10 August 2010  
Ref 08138

**Proposed Mixed Use Development  
Albert Street and Thomas Street, Chatswood**

I respond to your request to consider and provide advice in relation to the 'traffic issues' raised by the Department of Planning as follows:

**SP 4**

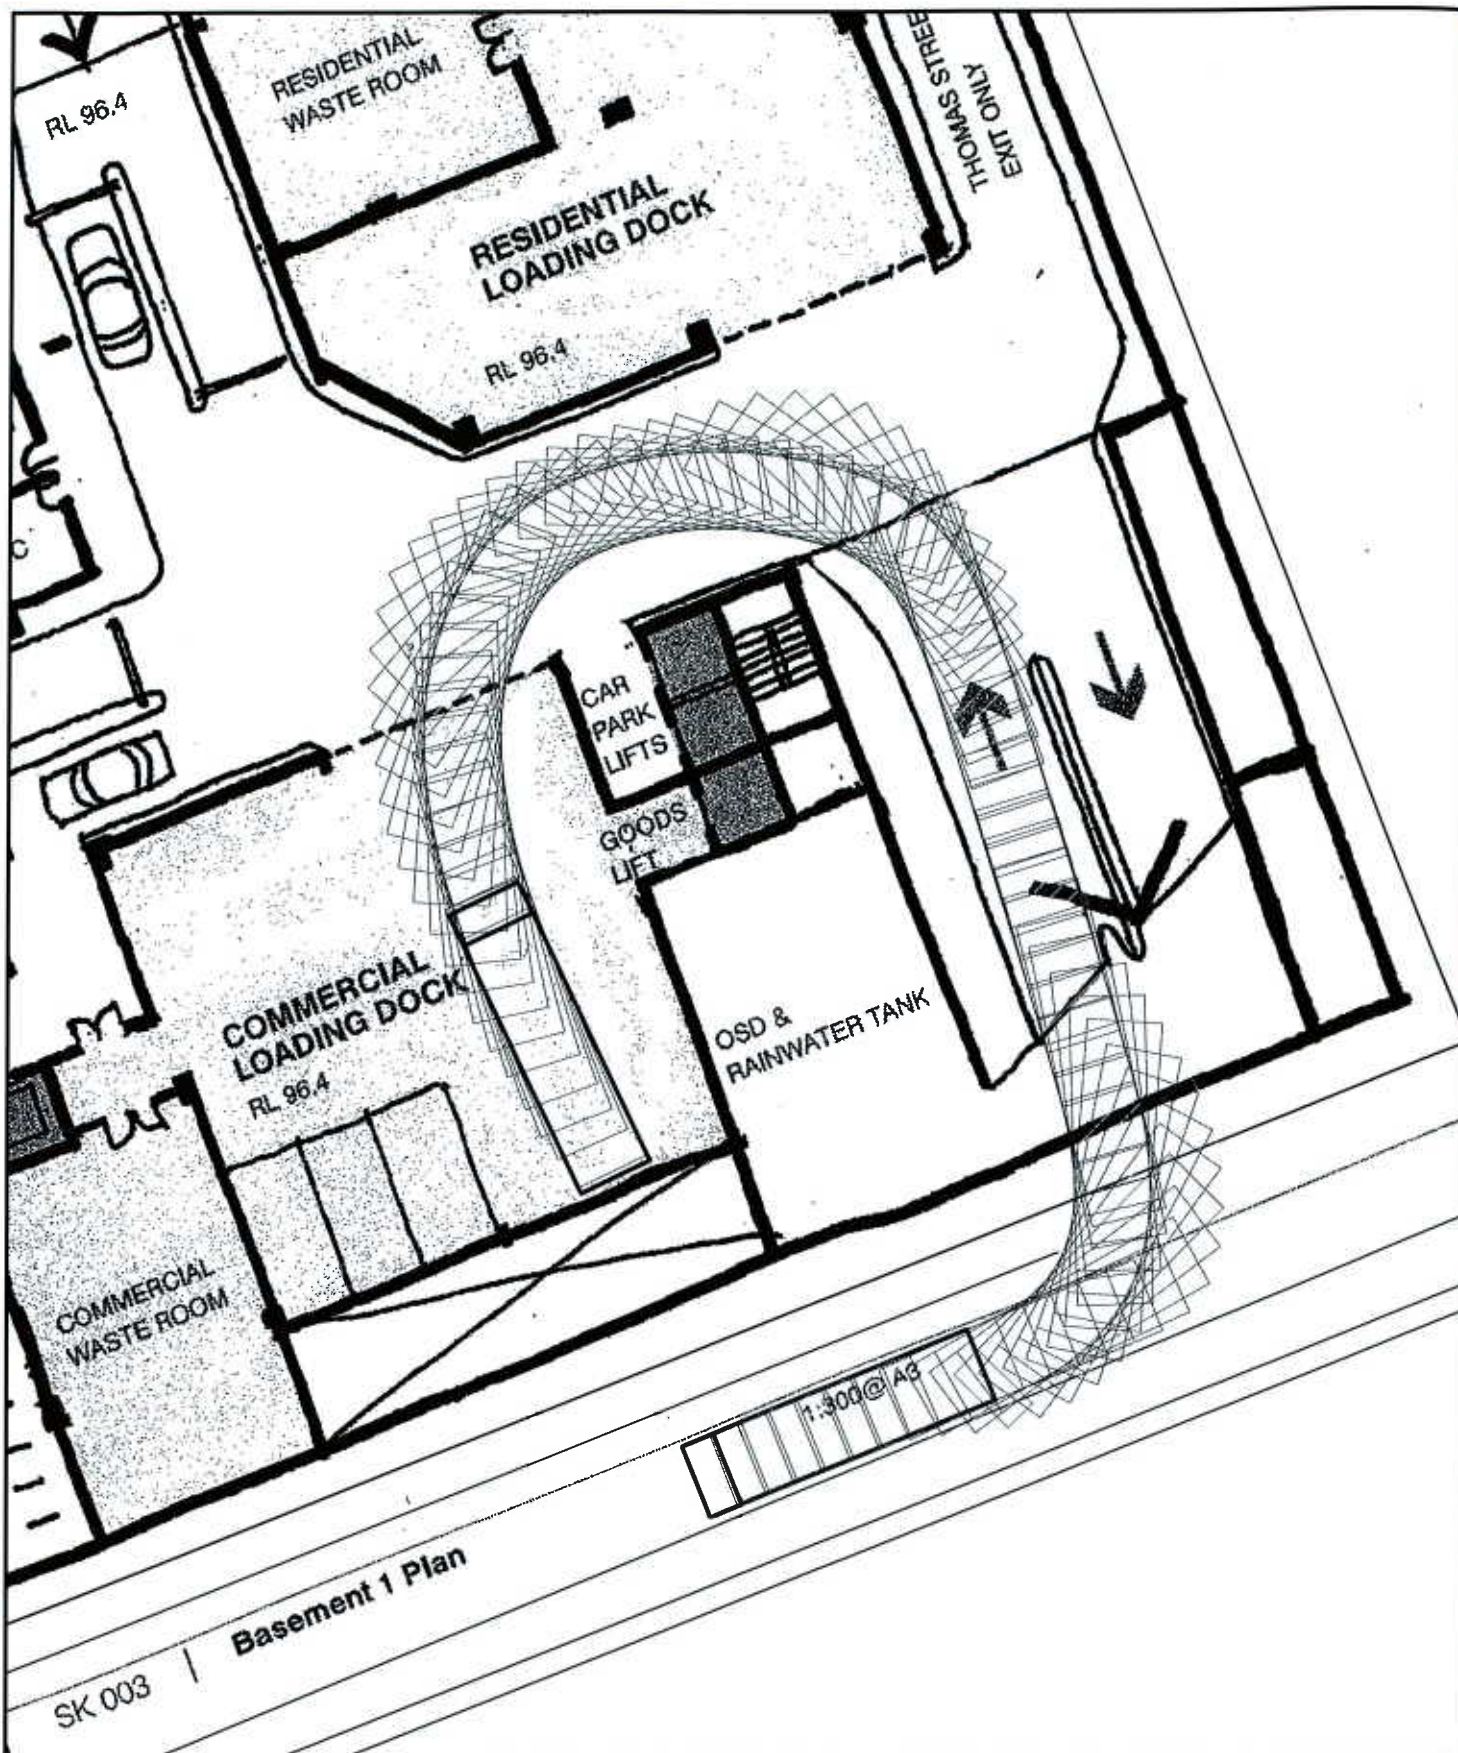
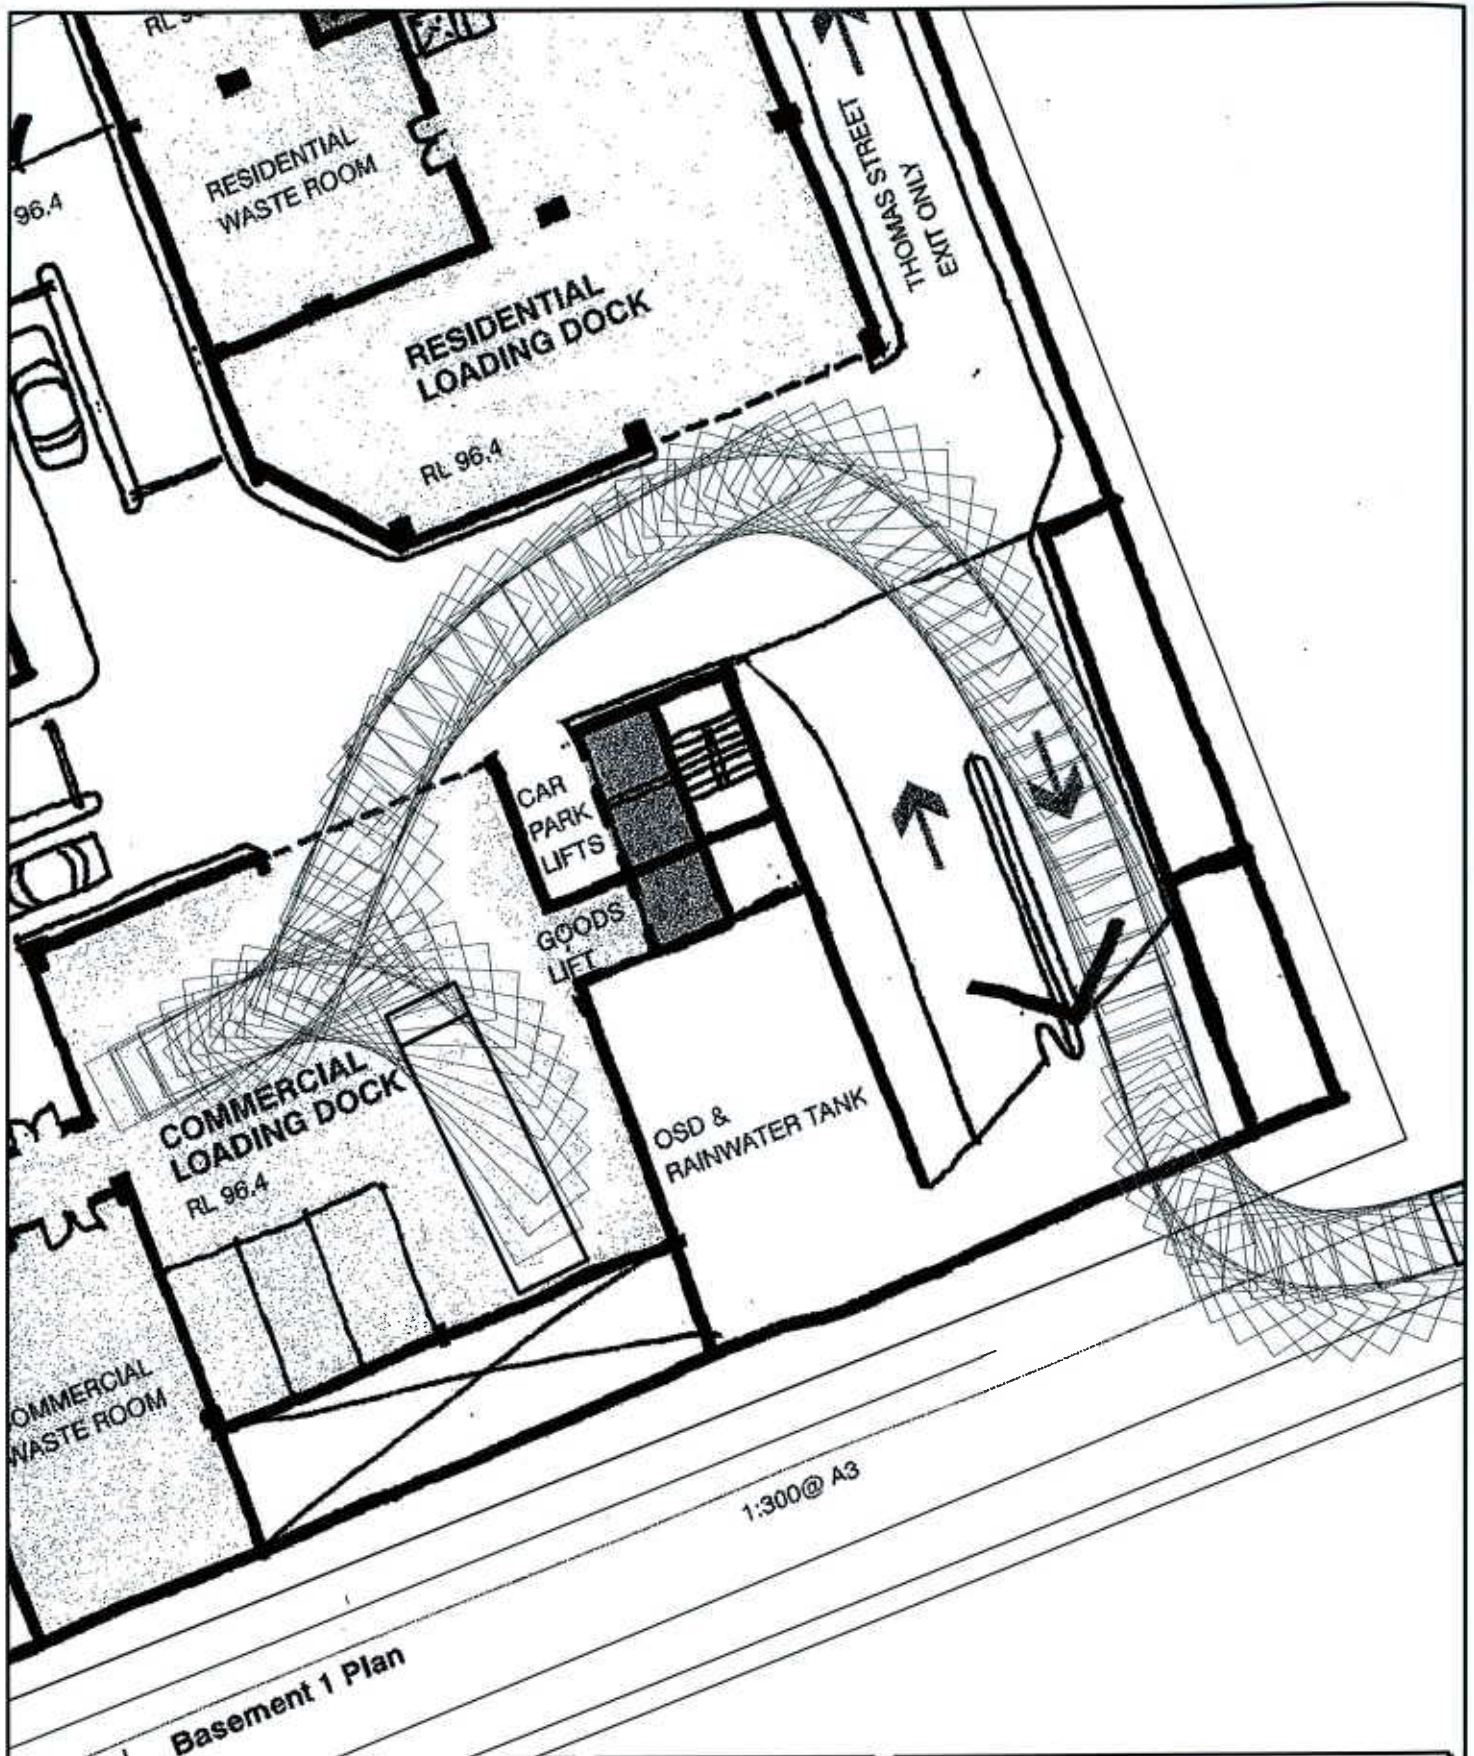
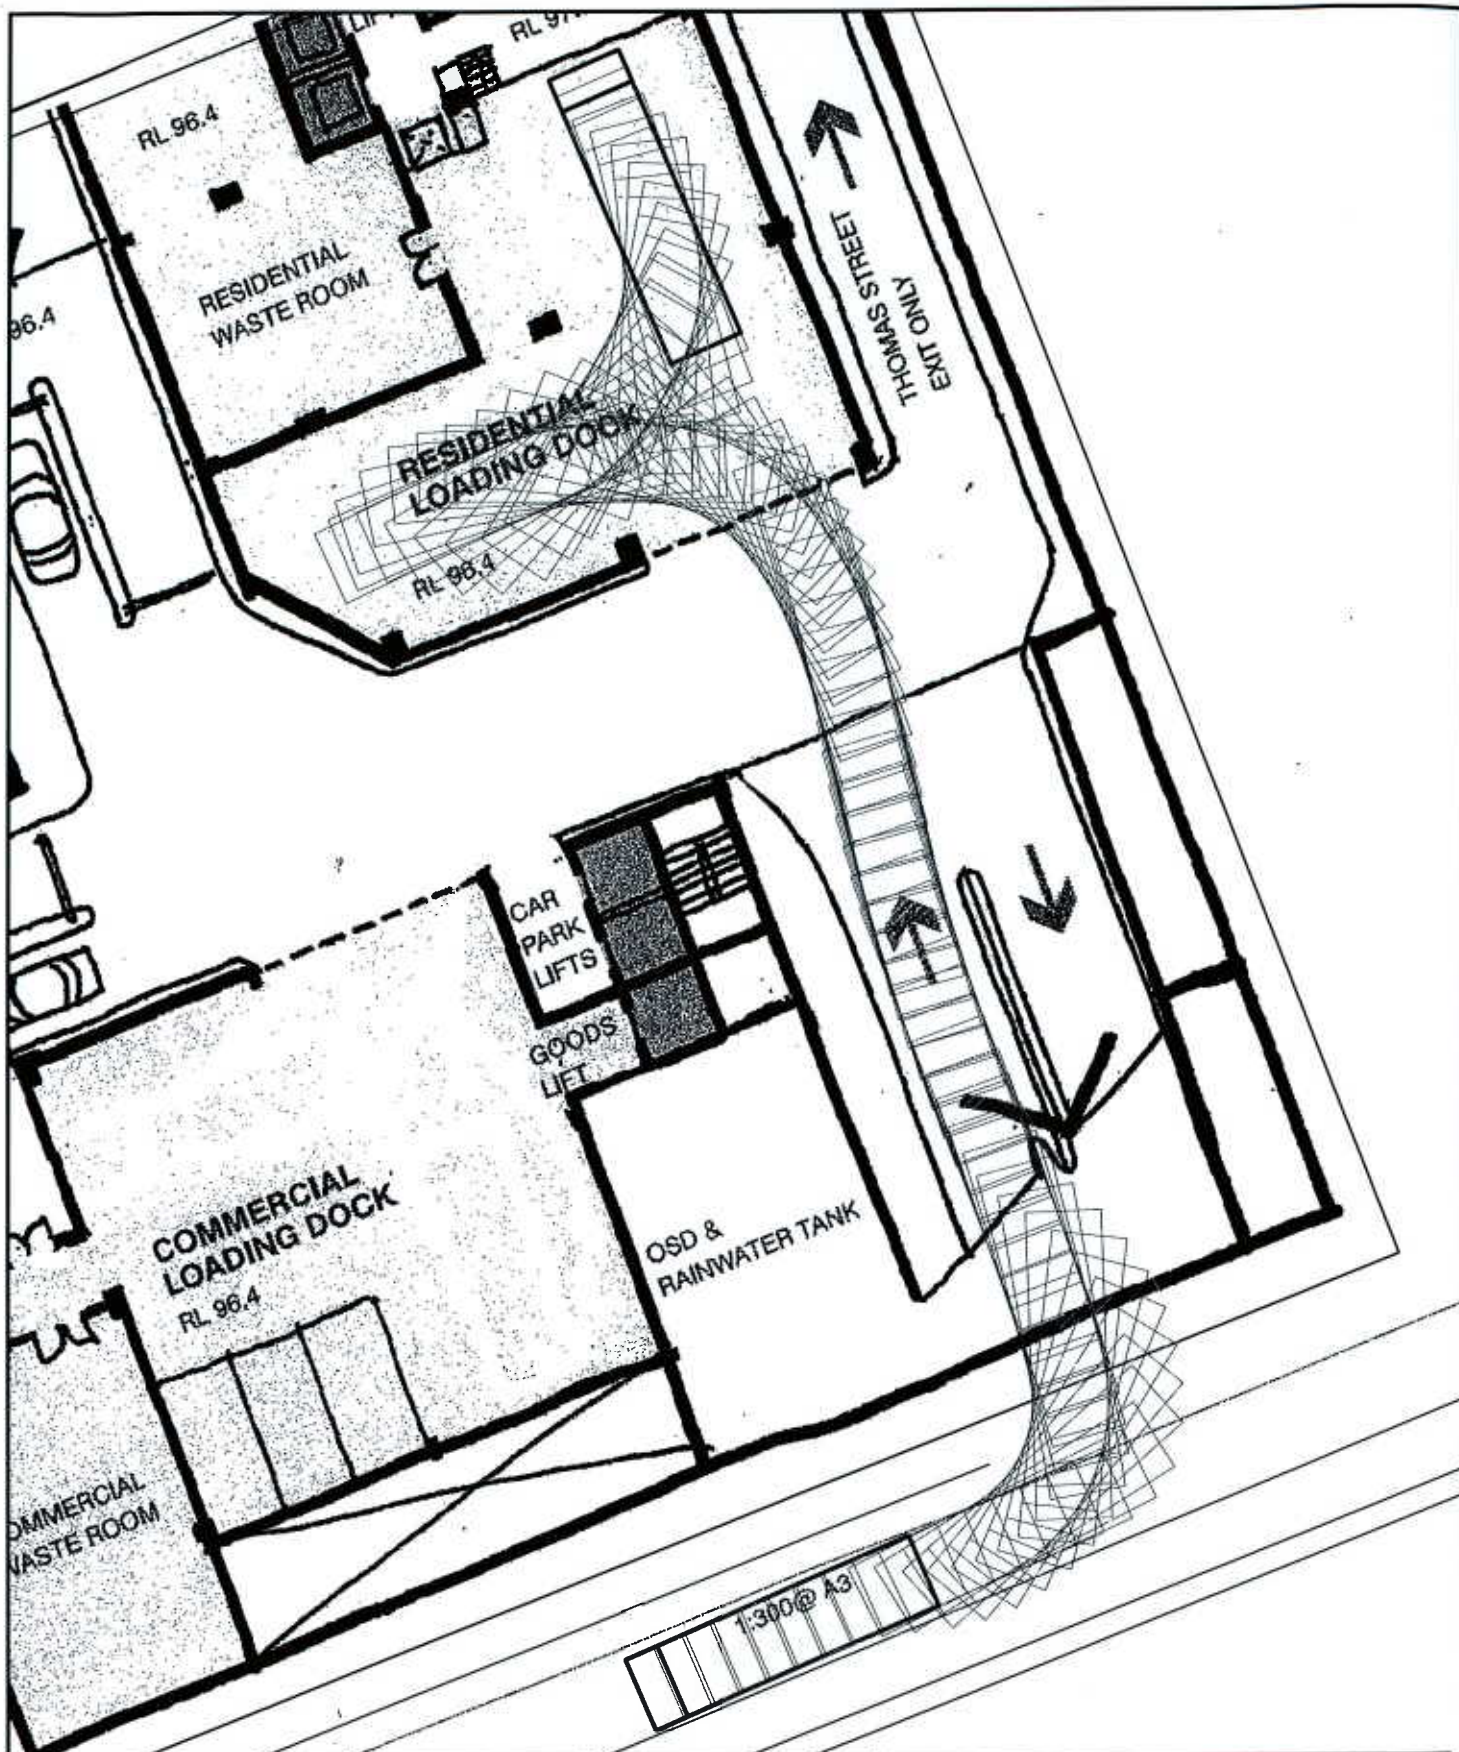
In relation to the ability for trucks to turn within the alternative loading dock arrangements (as shown on the PTW sketch) the attached turning paths SP1-8 clearly demonstrate the ability for MRV and refuse trucks to ingress, turnaround and egress.
